WASTE MANAGEMENT OF HAWAII, INC.
92-460 Farrington Highway
Kapolei, Hawaii 96707
(808) 668-2985

**RE: Solid Waste Management Permit Application
For renewal with Modification for Expansion, No. LF-0065-07
Waimanalo Gulch Sanitary Landfill
Located at: 92-460 Farrington Highway, Kapolei, Hawaii 96707**

On behalf of the City & County of Honolulu (CCH), Waste Management of Hawaii, Inc. (WMH), the operator of the Waimanalo Gulch Sanitary Landfill (WGSL), is responding to the Department of Health's (DOH) December 2, 2009 letter concerning comments to our expansion and renewal permit application and engineering design. WMH appreciates receiving and welcomes the opportunity to address DOH's comments.

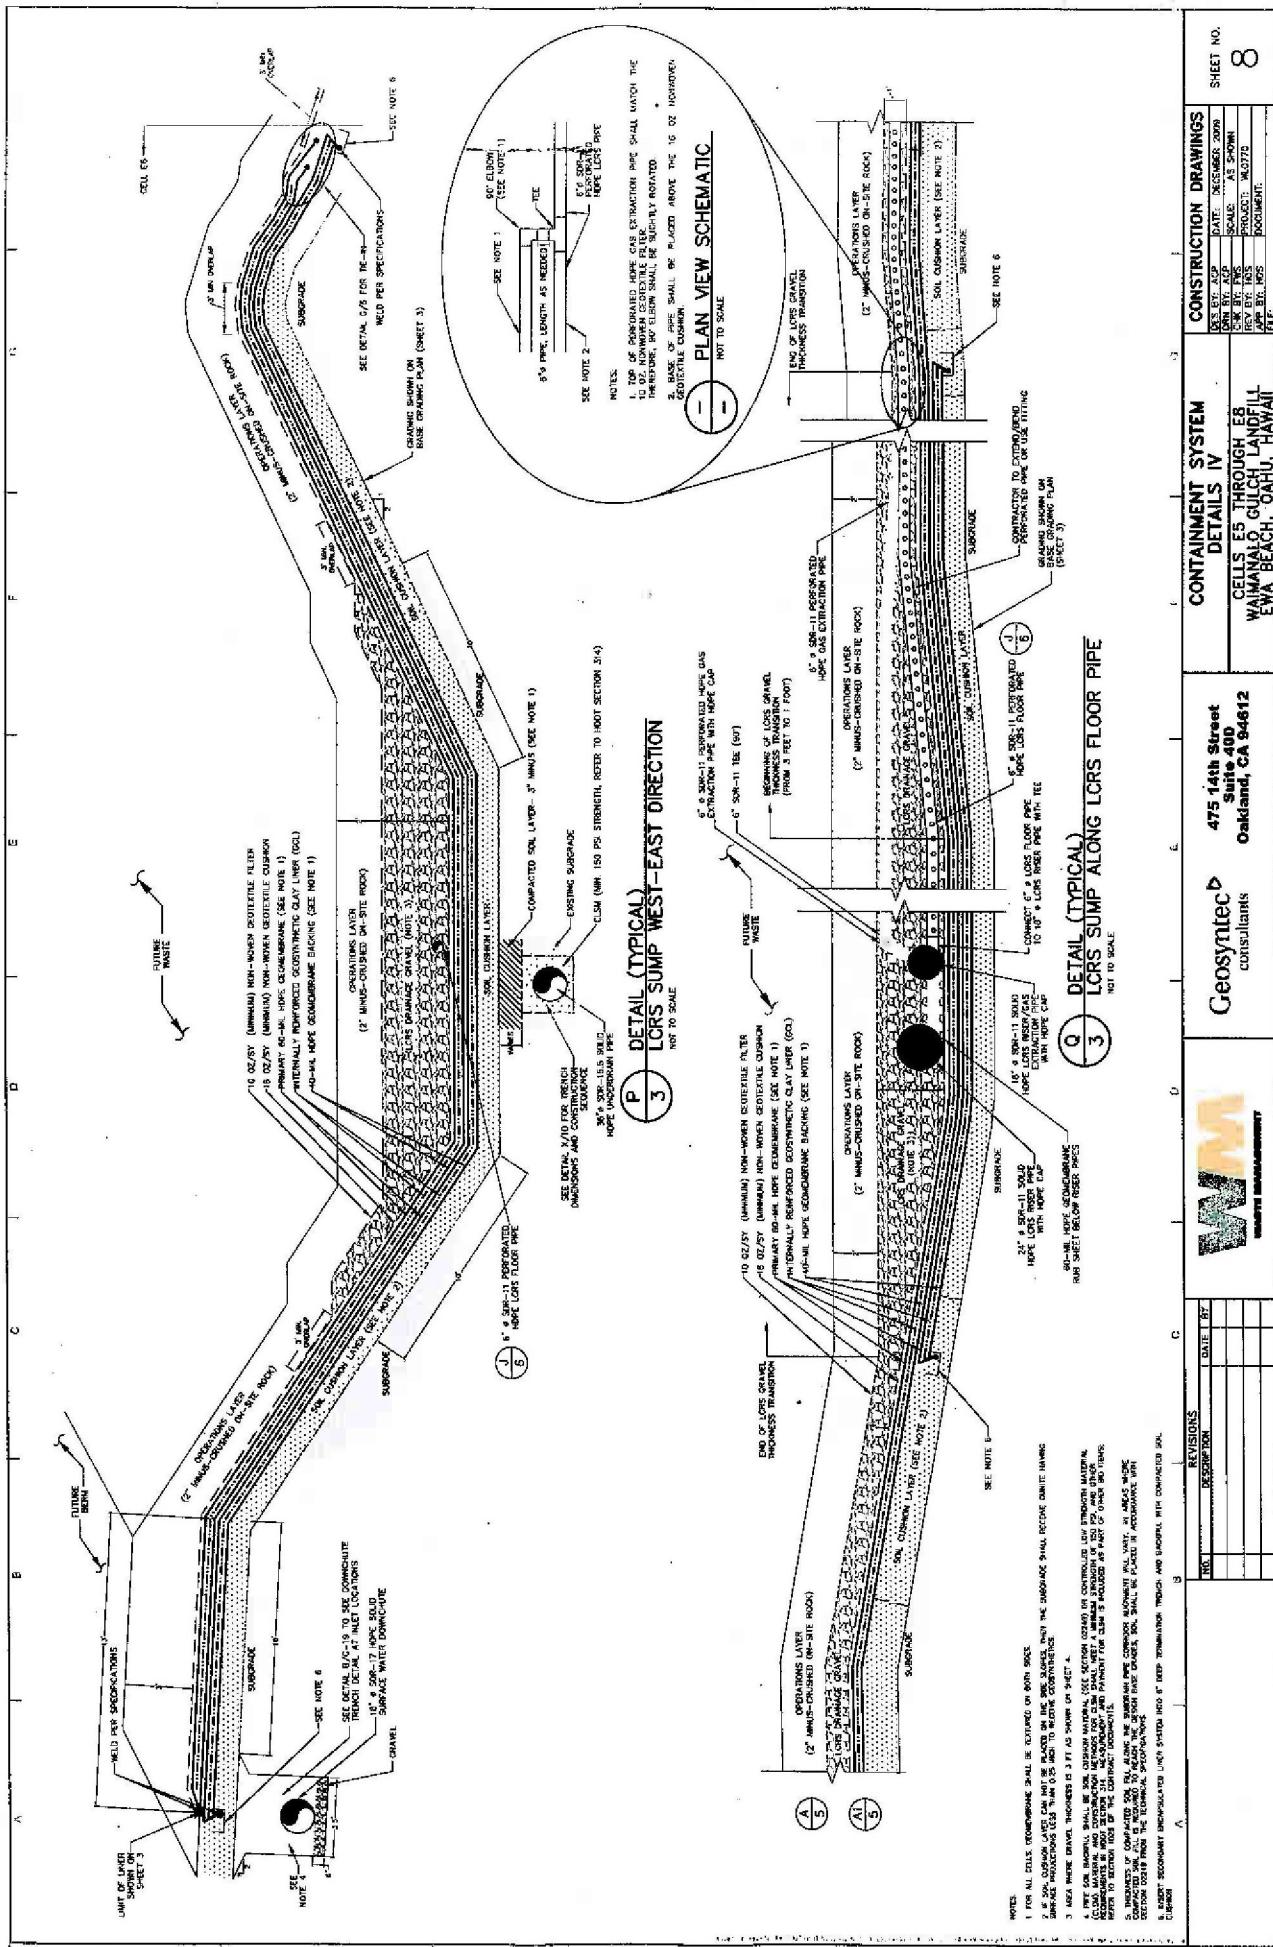
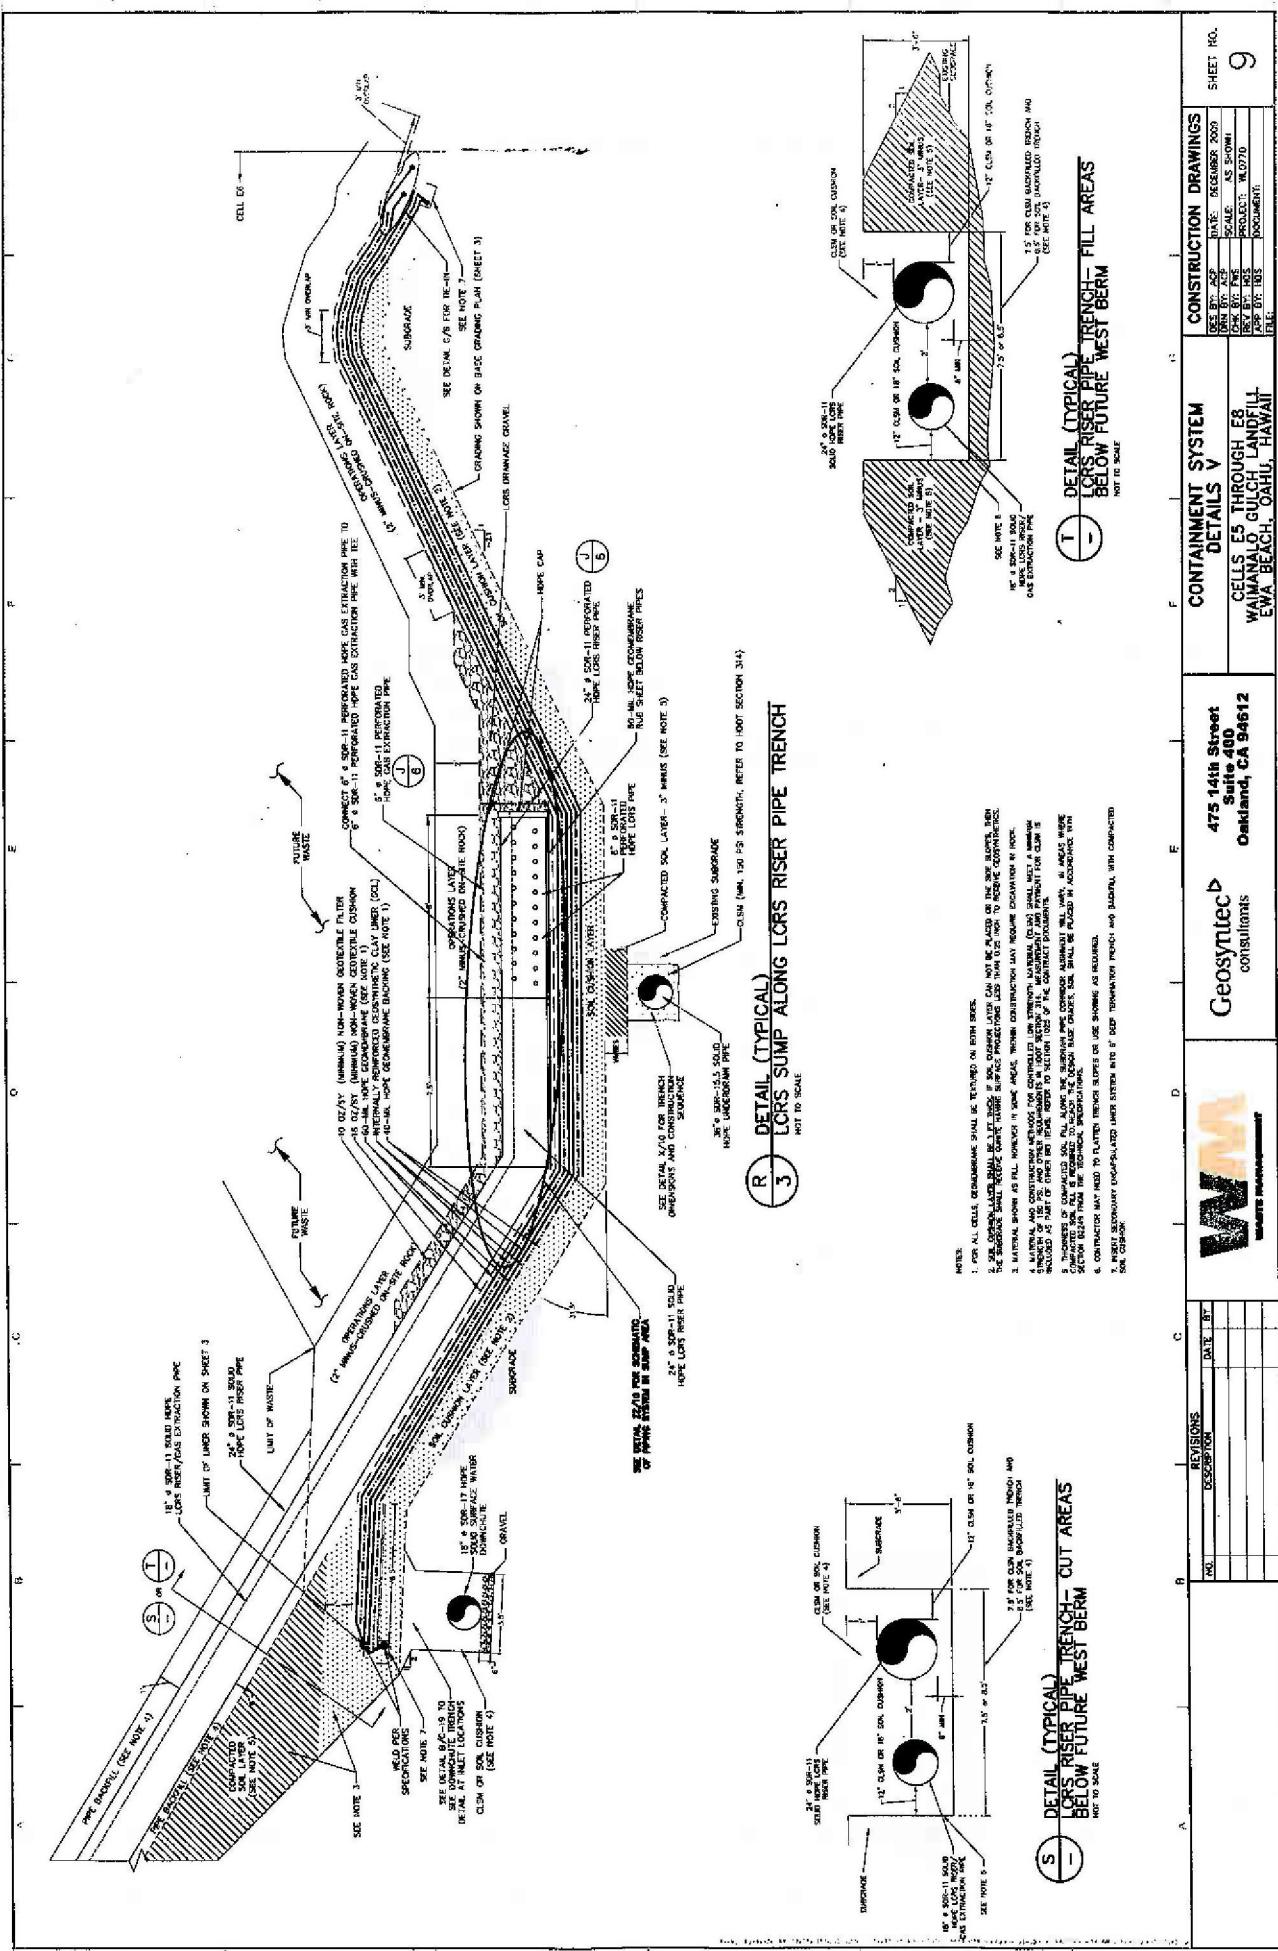
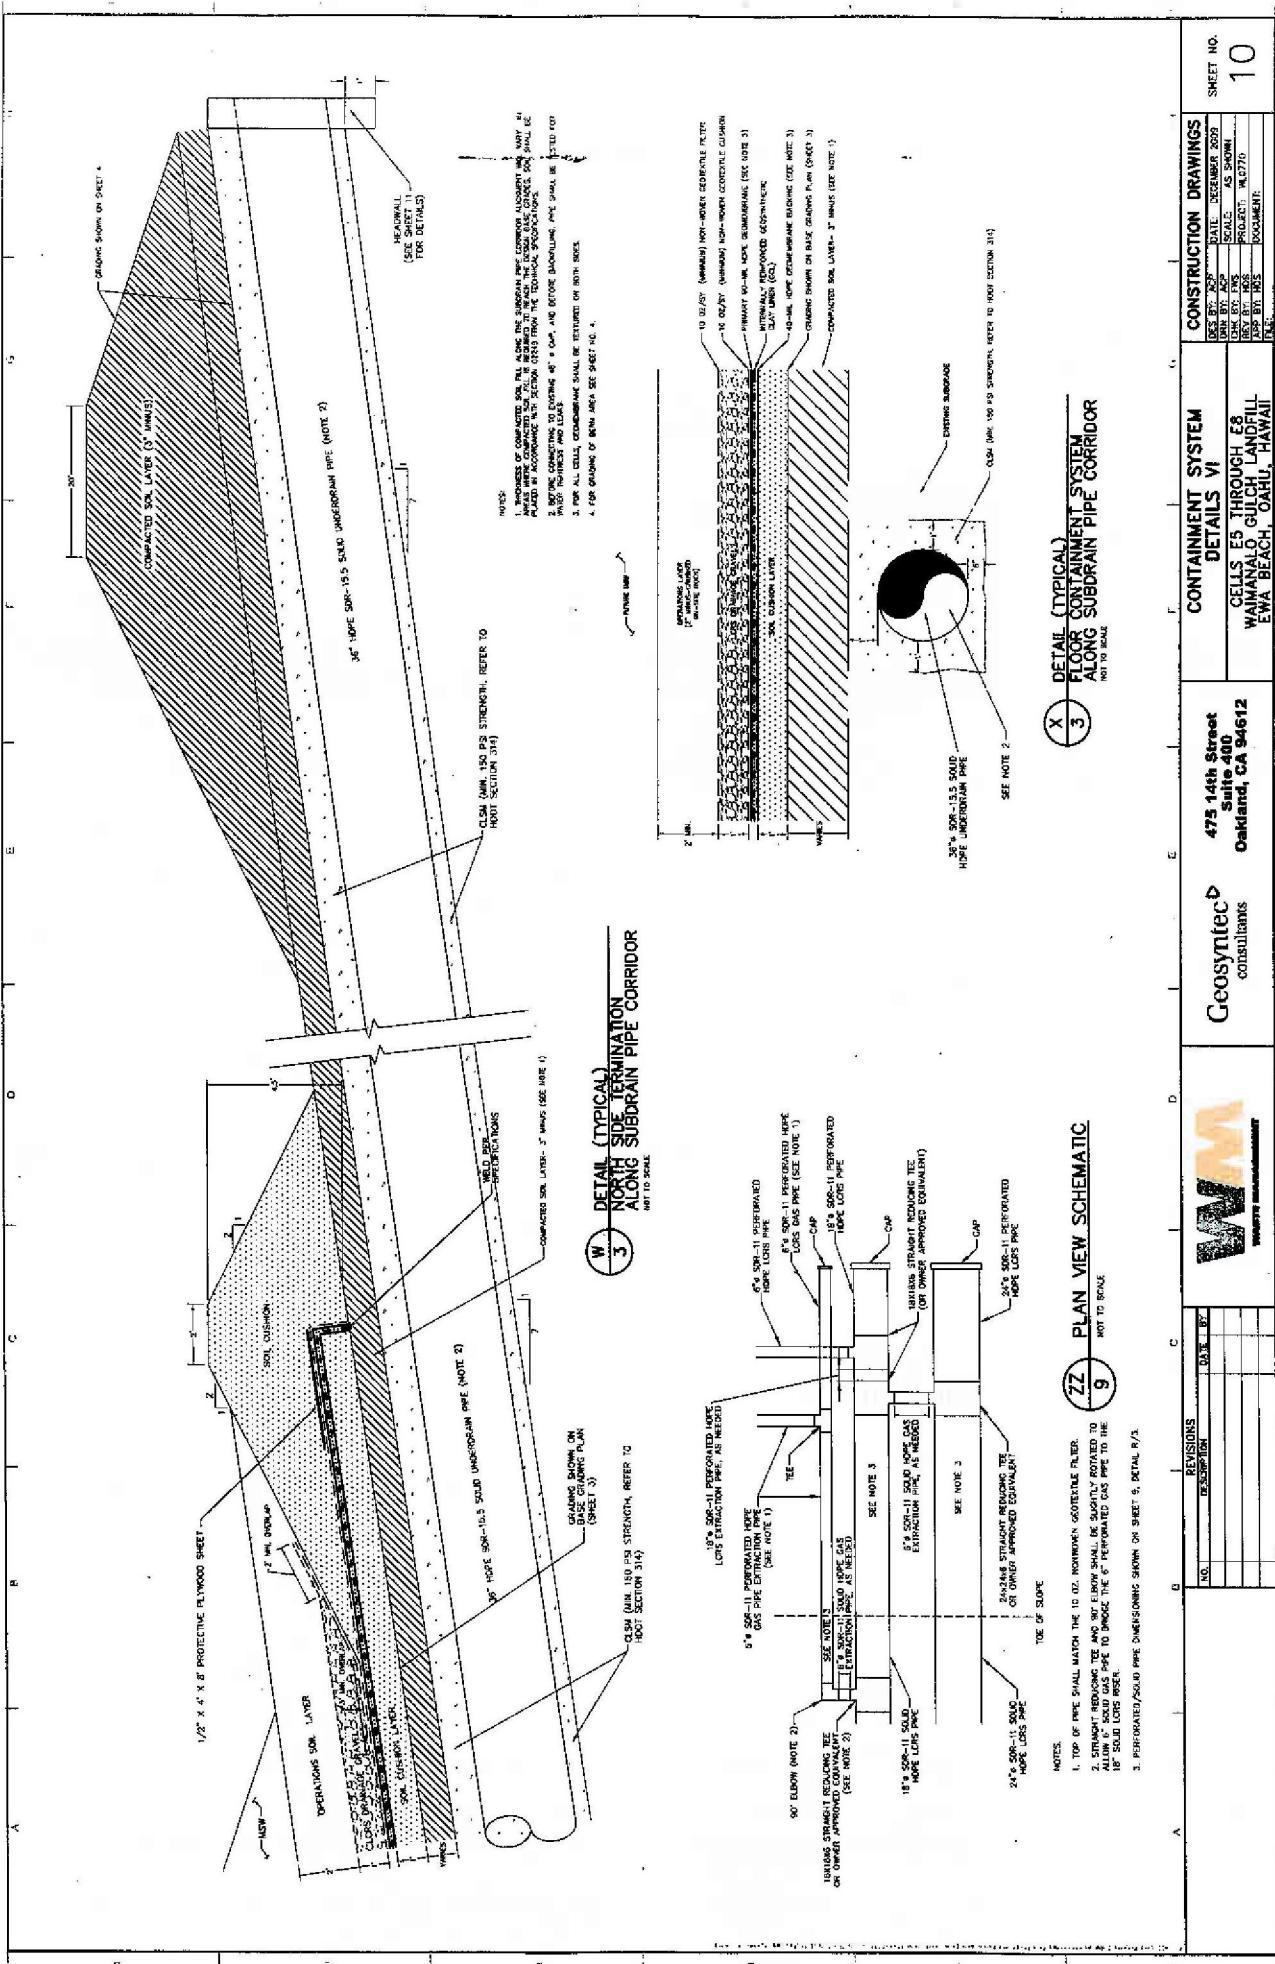
DOH Comment #2: *The extent, configuration, and elevations of the leachate removal sump cannot be determined because of the lack of elevation control points and horizontal and vertical dimensions. The compliance level cannot be determined. The sump area is required to have a double liner, if it is to have more than 12 inches of head. WMH has recently indicated a preference to duplicate sump risers and its placement on flat stock, as shown on the West Hawaii Landfill drawings, and in the repair to the 4B sump riser problem. Please explain the change in preference, as we also preferred the redundancy and added protection.*

WM Response #2: As described above, the grades in the area of the sump are provided electronically to the contractor. Additionally, the above list also provides a few sump control points for your understanding.

WMH will be pumping leachate as needed to maintain a maximum 12 inch head of leachate above the liner system. Since the sump will have more than 12 inches of leachate, therefore, as requested, we have added a double liner in this area. Also, as requested, we have incorporated a duplicate sump riser and placed both risers on a flat HDPE rub-sheet which is functionally superior to flat stock. The items described are shown on Drawings 8, 9, and 10.
